Intel[®] Mobile Celeron[™] Processor Specification Update

Release Date: December 1999

Order Number: 244444-010

Figure 2. Workaround Flowchart: SMBALERT#-Driven System

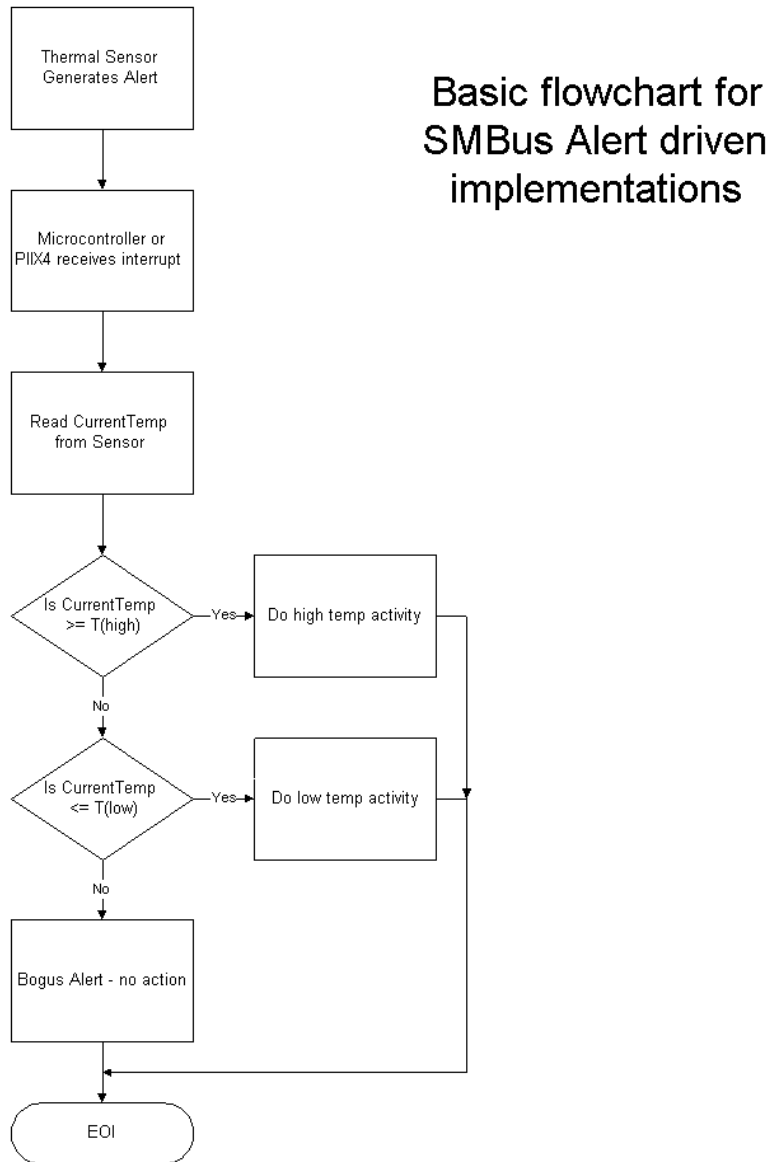
H29. Thermal Sensor May Assert SMBALERT# Incorrectly

Workaround: Three different (mutually exclusive) workarounds are possible:

1. Before servicing an interrupt from the thermal sensor, read and compare the processor thermal reading with the threshold limits (T_{HIGH} or T_{LOW}). Figures 2 and 3 provide basic flowcharts for the implementation of this workaround in an interrupt driven system.
2. If the firmware implemented polls the Status Register only, then before taking any action, re-read the temperature register and do a comparison with the alarm threshold limits (T_{HIGH} or T_{LOW}) to determine if the value is actually still within the temperature window.
3. Use a temperature polling scheme to monitor the processor temperature.

Figure 5.3. Surface-Mount BGA1 Package—Top and Side View

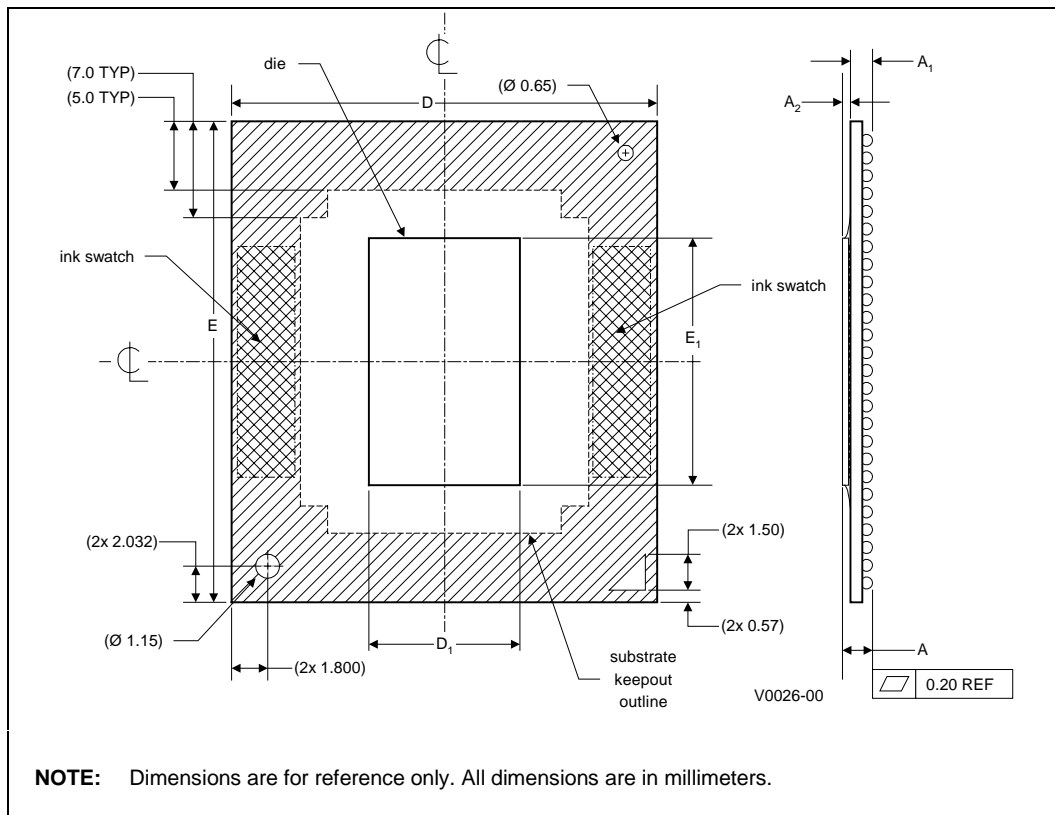
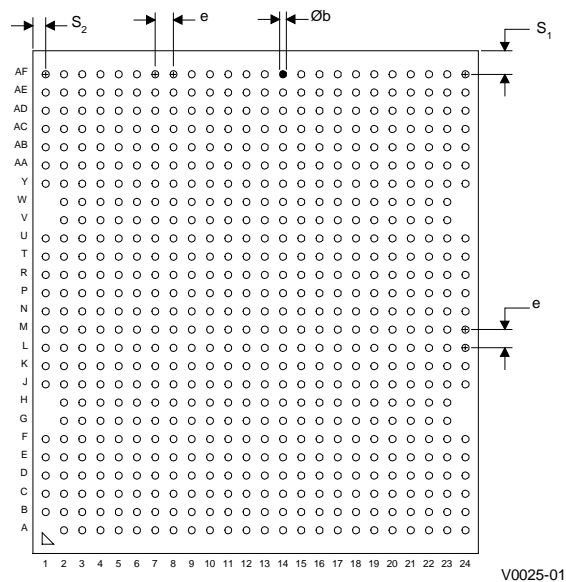
The following table and figures show the updated mechanical specifications for the BGA1 package, listed as Table 5.2, Figure 5.3 and 5.4, respectively, in the *Intel® Mobile Celeron™ Processor in BGA Package at 333 MHz, 300 MHz and 266 MHz* datasheet.

1. The number shown here is different from that in the 244444-004 version of this specification update. The maximum reference number is used.

Figure 3.3 Generic Clock Waveform

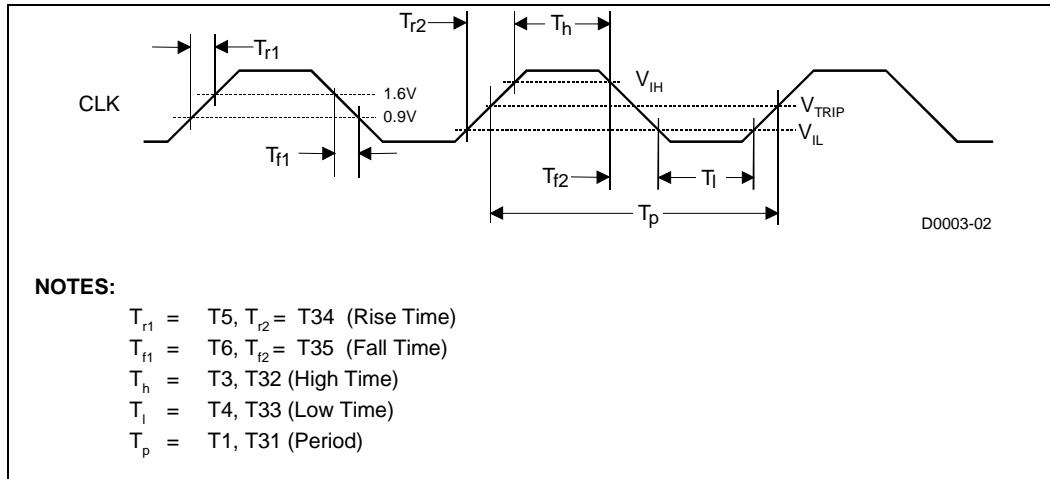
H11. Generic Clock Waveform Figure

Figure 3.3 in the *Intel® Mobile Celeron™ Processor in μ PGA1 and BGA1 Packages at 366 MHz, 333 MHz, 300 MHz, and 266 MHz* datasheet (Order Number 245112-003) has been updated. The following figure is to replace the one in the above document.
